PLANNING & ZONING
October 08, 2026
5:30 PM
City Hall

MILLS CITY PLANNING COMMISSION

Development Plan Review –

Wyoming Classical Academy (WCA) requests Development Plan approval for Phase II of its existing charter school campus at 6389 Poison Spider Lane. Phase II expands the school from grades K–9 to K–12. Development Plan review is required under Title 17 - 10.40(3)(j) (public or private schools) and 10.40(3)(k) (creation or enlargement of off-street parking lots). The addition also exceeds the 5,000 sq. ft. threshold noted in 10.40(1).

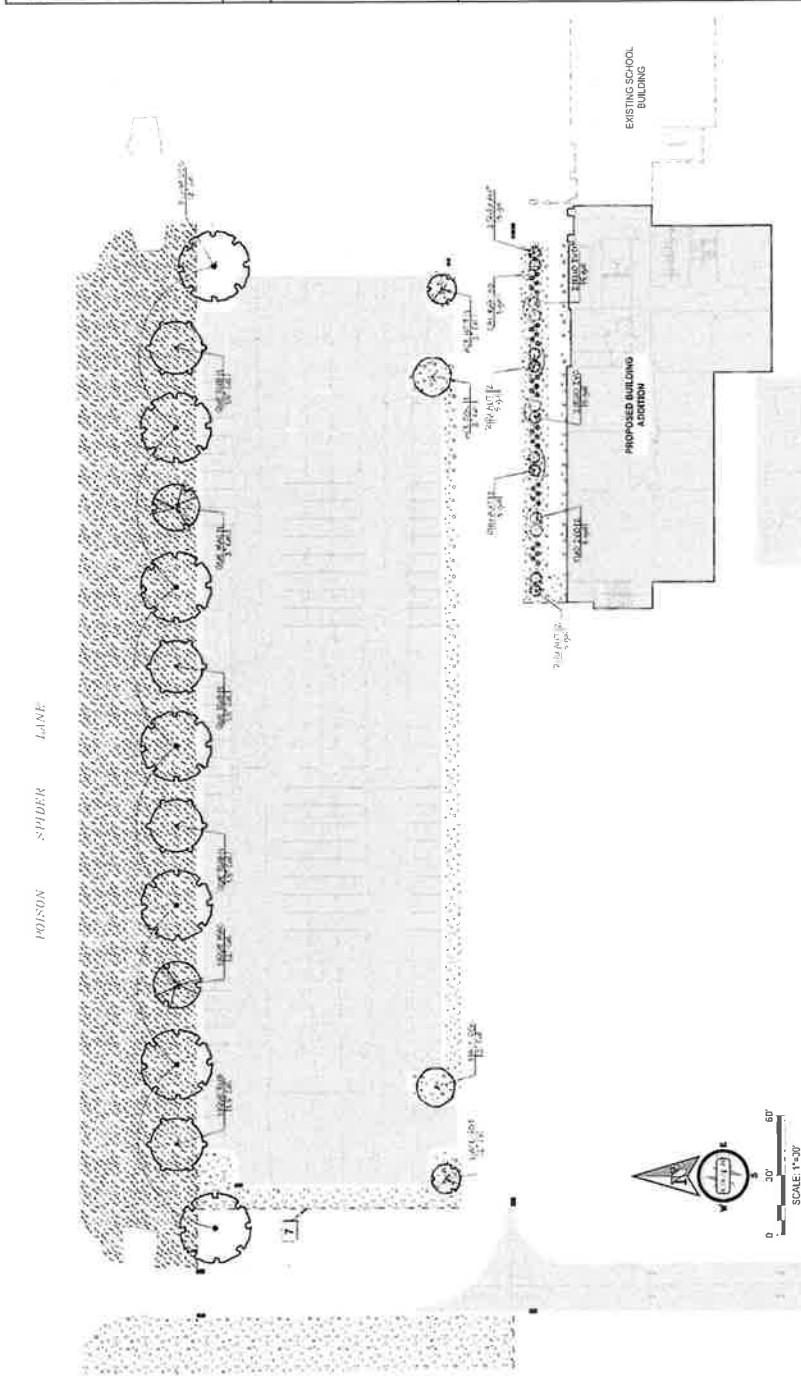
Sheet L1.0 (CEPI, 6/22/2026) predates the 8/28/2026 parking layout. It shows none of the interior islands, is still marked "Preliminary," and lists the project location as Casper, Wyoming. 40.40(3) requires the Landscape Plan to be approved with the Development Plan, and the revised plan must include:

- At least one tree and one shrub in every parking island (40.40(7)(d)(ii)).
- Irrigation for all planted areas (40.40(7)(h)).
- Existing landscaped areas and vegetation, noting what stays and what is removed (40.40(4)(d); 10.40(6)).
- Site and landscape area calculations and required plant quantities (40.40(4)(b)).
- Planting and irrigation for the 5-ft. strip on Sheet C500, which is labeled only "park strip" with no surface or plantings specified (40.40(7)(e)).
- Plant materials consistent with Building Casper's Urban Forest (40.40(5)).

Based on L1.0 quantities, rock mulch makes up about 29 percent of the landscaped area, under the 60 percent inorganic limit in 40.40(7)(b). This should be recalculated on the revised plan (Conditions 15–16).

2. Update L1.0 to the 8/28/26 layout. Remove the "Preliminary" label and correct the location to Mills.

DATE: 08/28/2006	OVERALL UTILITY PLAN
PROJECT: A44-081	SHEET NUMBER
MANAGER: J.R.J.	C400
REVISIONS	
NO. DATE / DESC	
1 08/27/2006	
2 08/28/2006	
3 08/28/2006

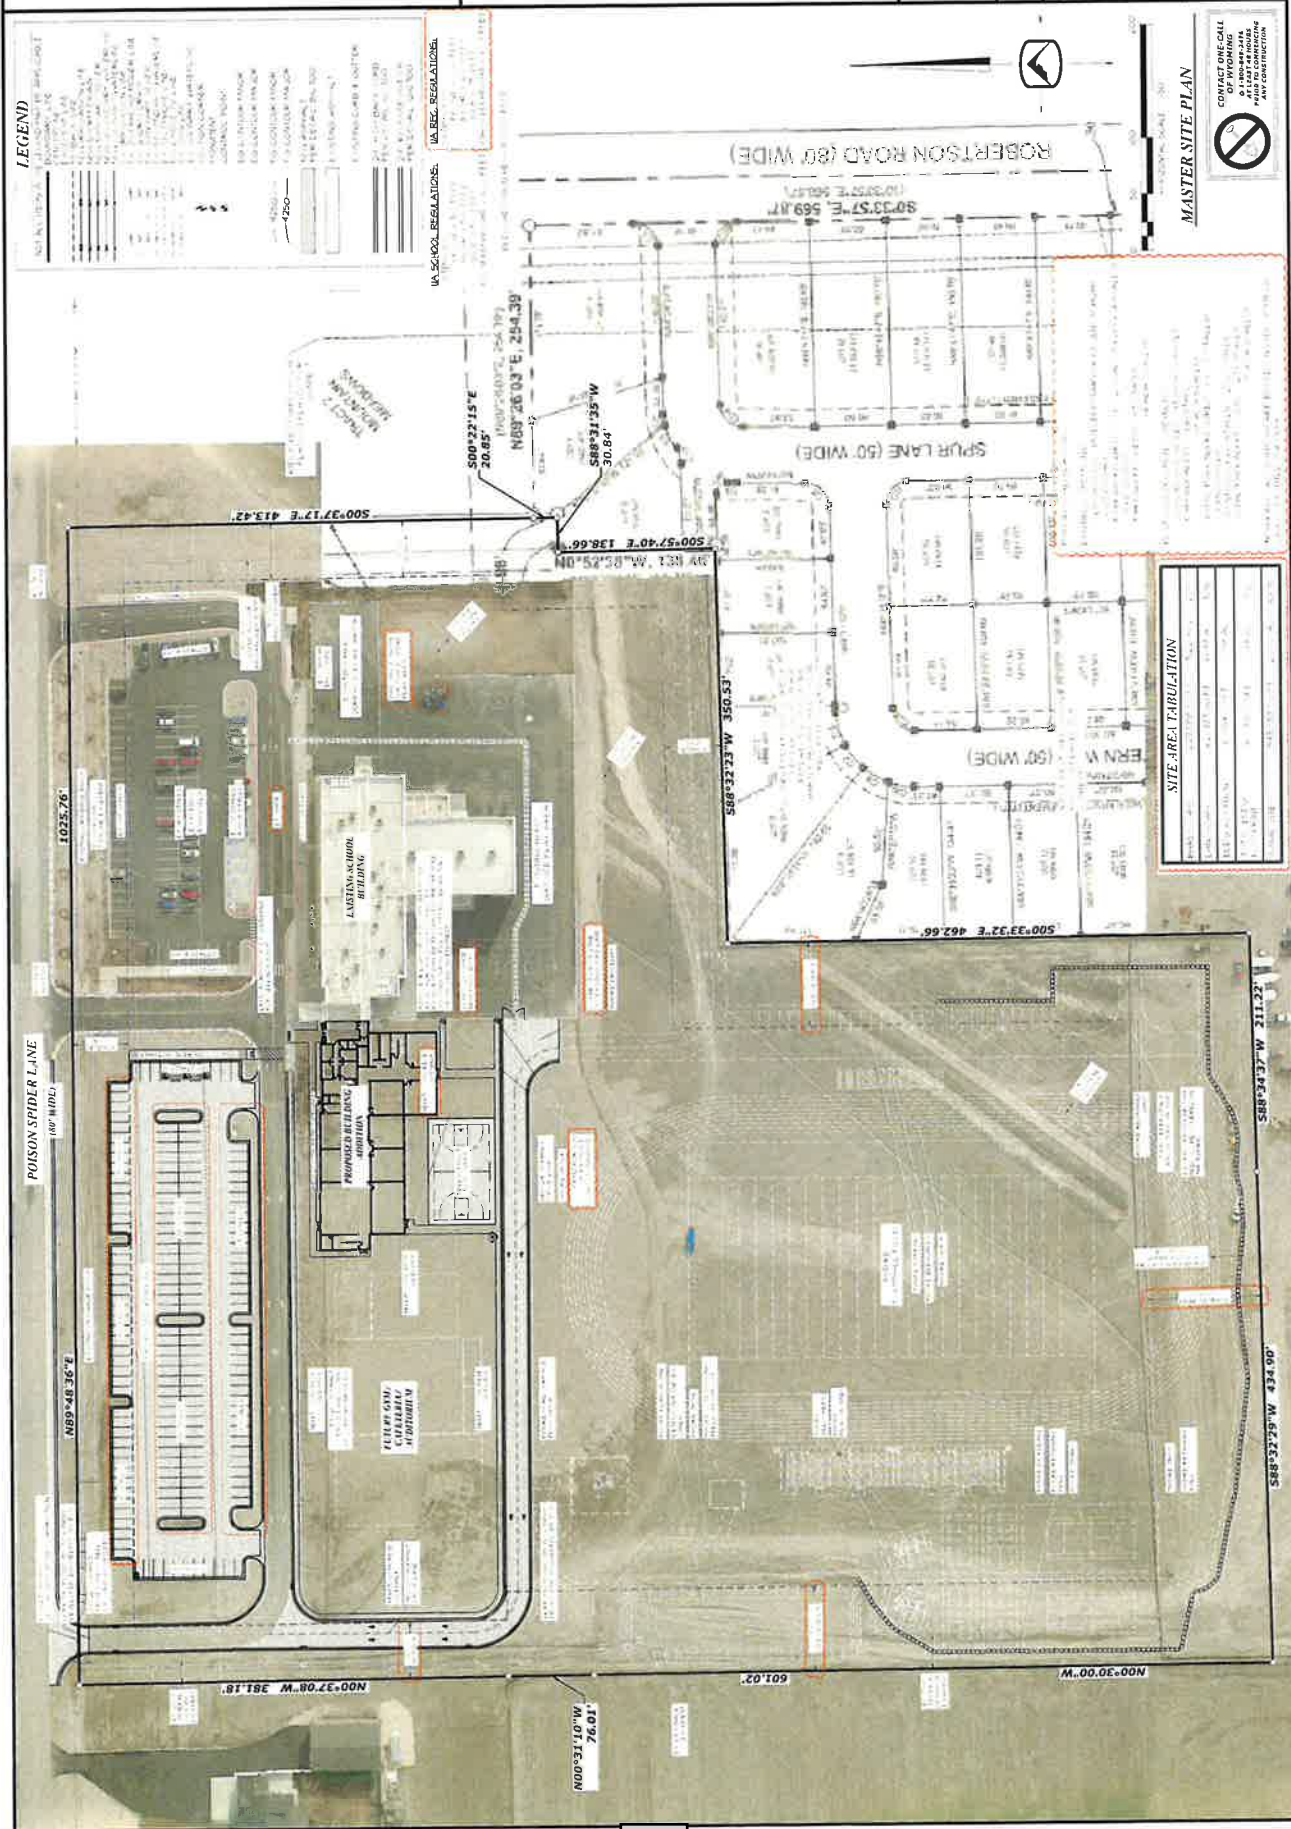
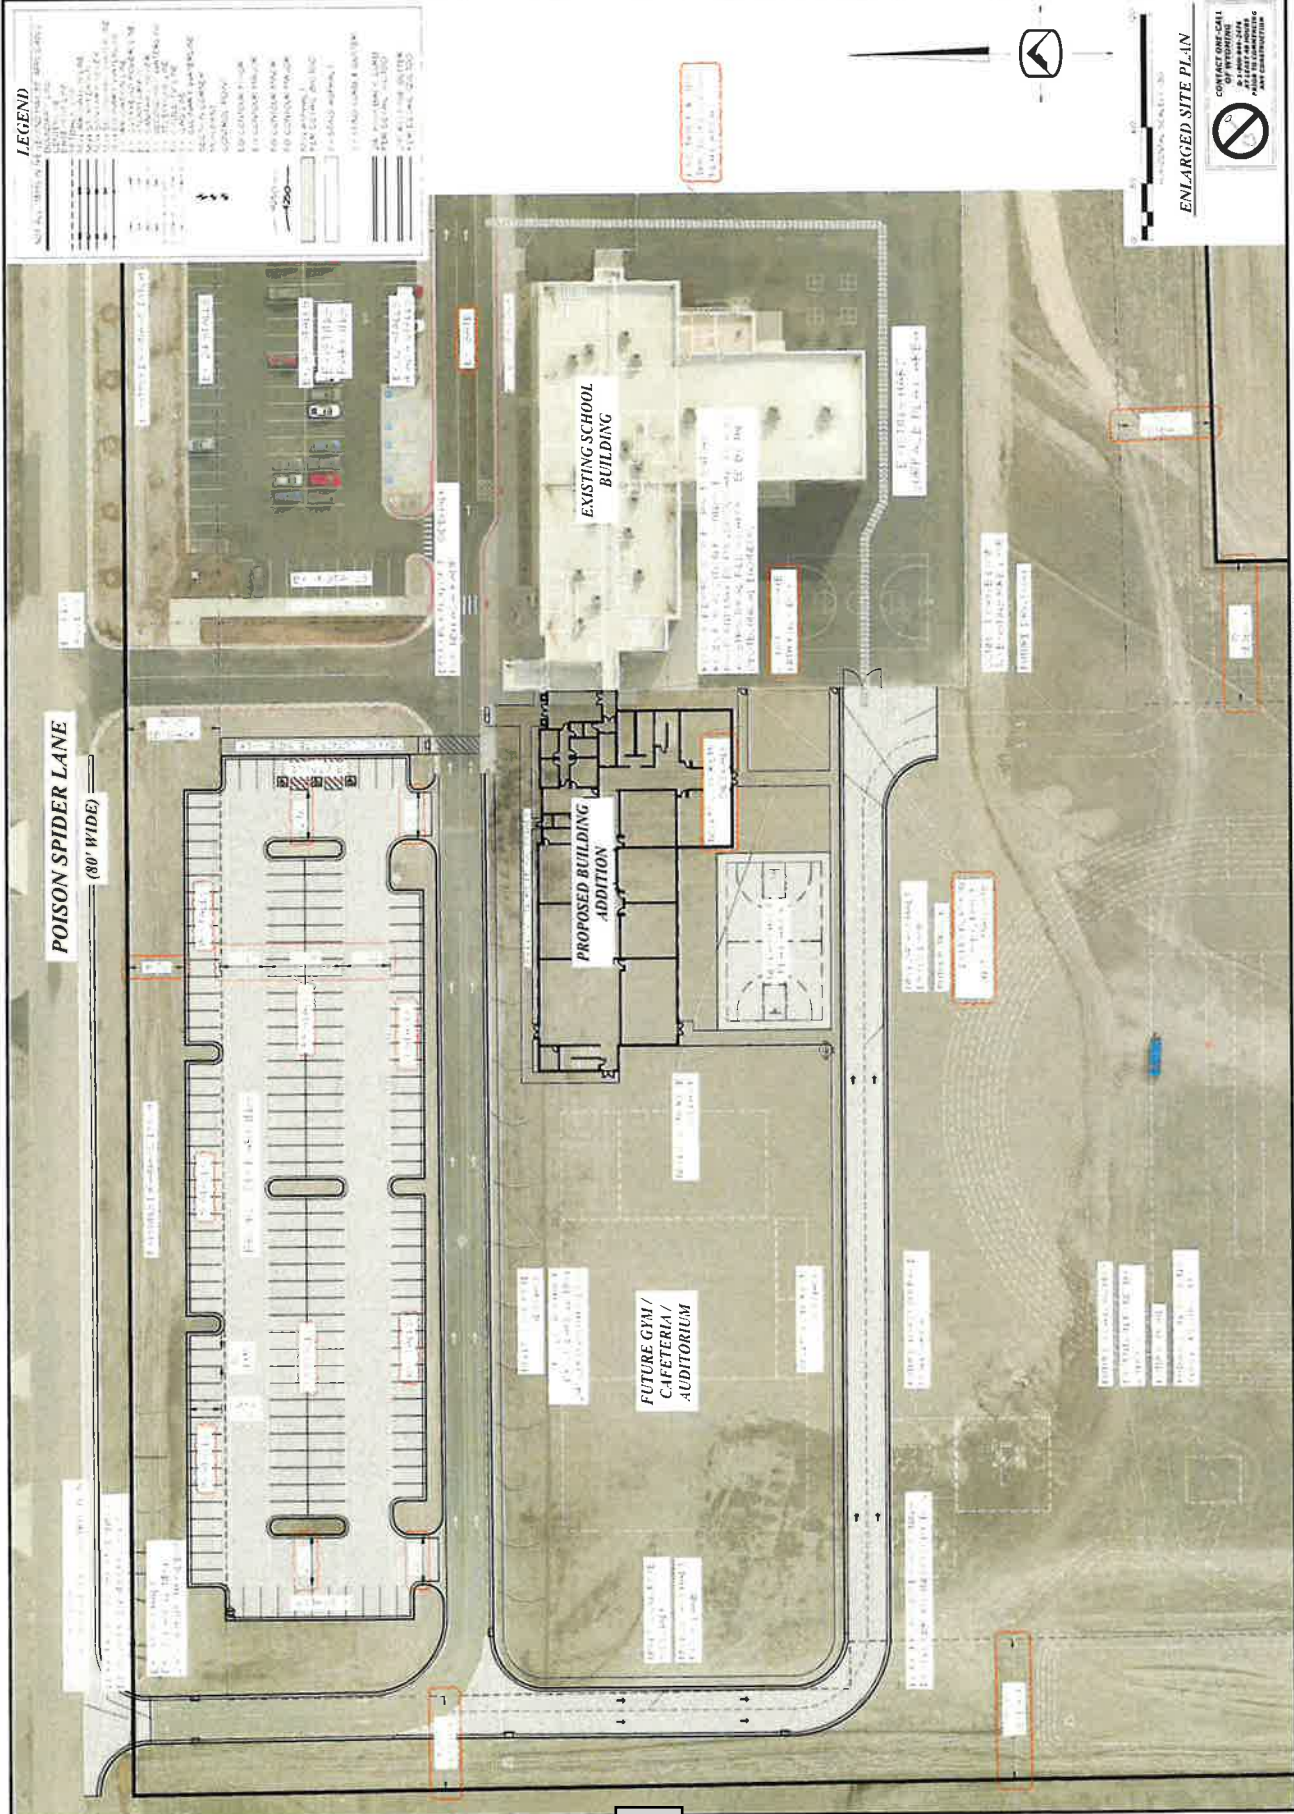
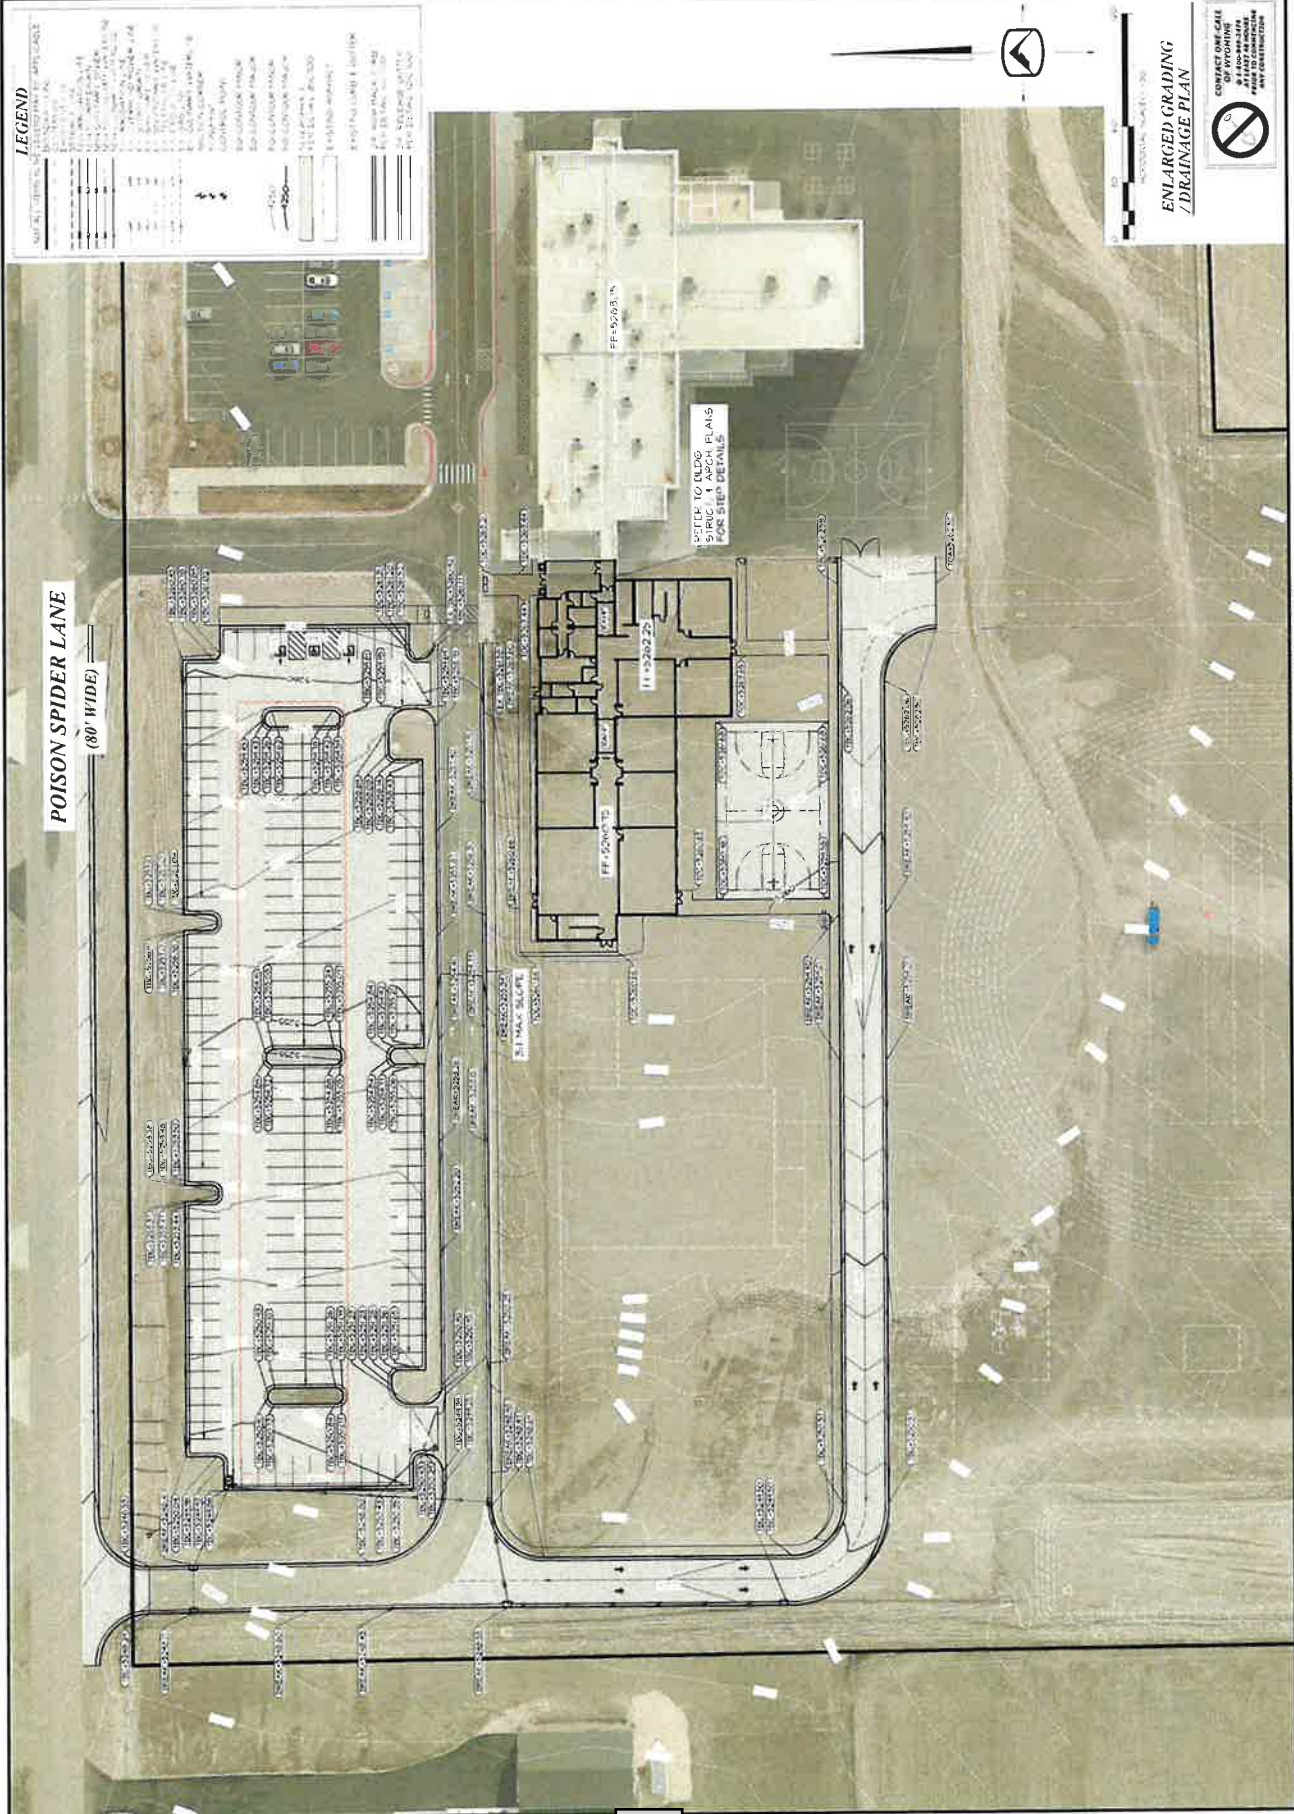
Based on a required fire flow of 1,700 gpm, the Fire Chief has determined that **two hydrants** are needed for the new school, with the additional hydrant at the northwest corner in front of the addition. The Applicant's fire flow analysis should confirm this. The Fire Chief accepts rear fire access through the existing hard surface, provided it is striped as a fire lane and kept clear during car line operations. The Mills engineering review of Sheet C400 requires the following:

1 Response: The updated utility plans propose relocating the existing hydrant in the new parking lot to the NW corner of the front of the addition. See sheets C400 and C401.

2 Response: The C-900 fire line supplying the proposed fire hydrant has been upsized to 8-in. The 45 bends have been removed, and the utility sheets include a callout to install a tee at the hydrant with a blind flange on the west connection for future needs. See sheets C400 and C401.

POISON SPIDER LANE IMPROVEMENTS

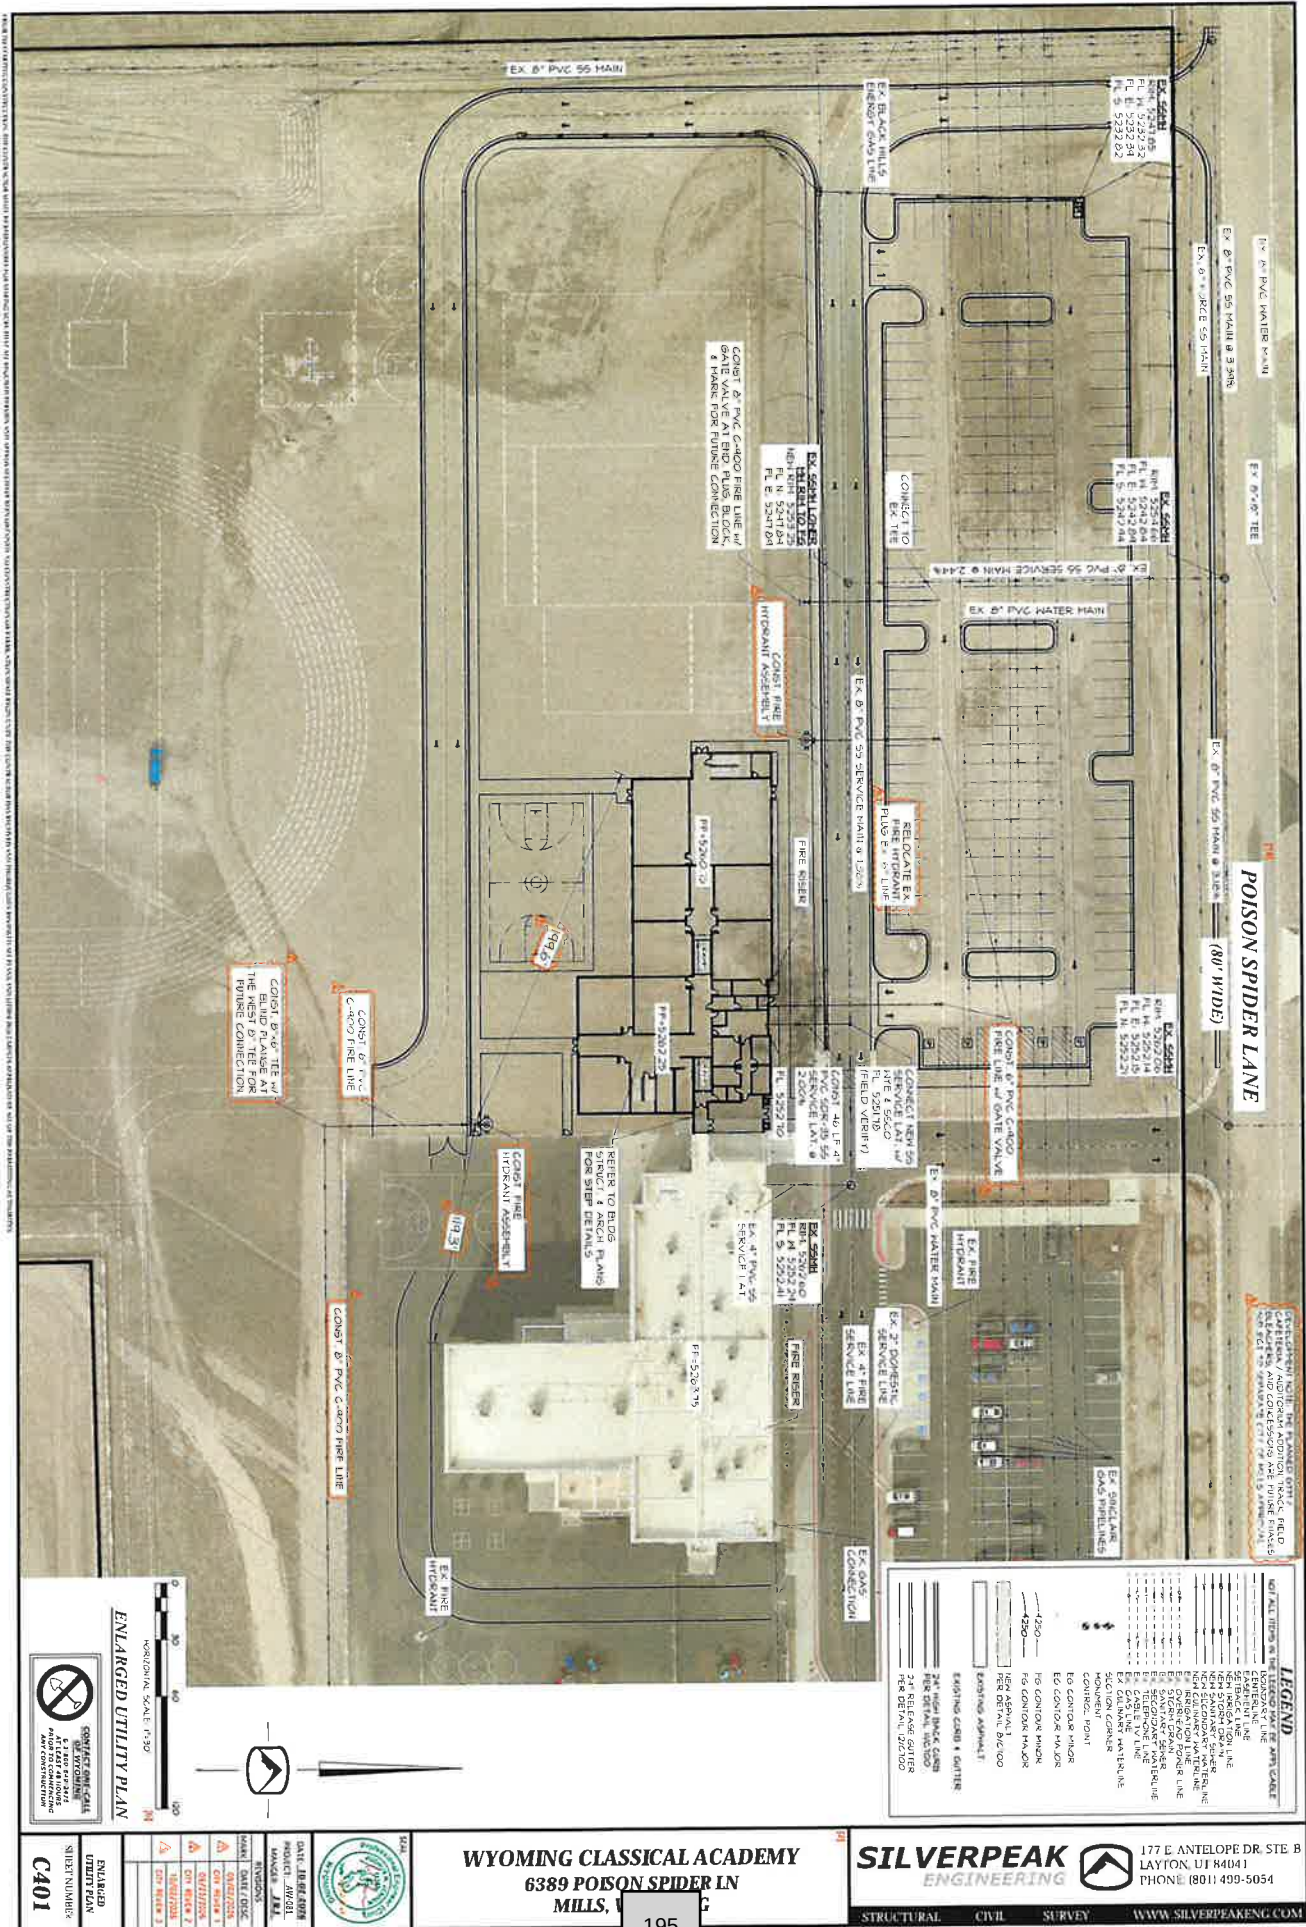
- **Poison Spider Lane frontage:** 7 ft. of widening, curb and gutter, and a 5-ft. park strip along the site frontage (Sheet C500).
- **Utilities:** a new fire hydrant south of the addition fed by a 6-in. C900 fire line from the 8-in. main on the east boundary, plus an 8-in. stub for future connection (Sheets C400/C401).

1 Response: Runoff collected in the new Poison Spider curb and gutter will be conveyed to the existing drainage ditch by curb cuts allowing overland flow into the ditch. See new detail 2/C500.
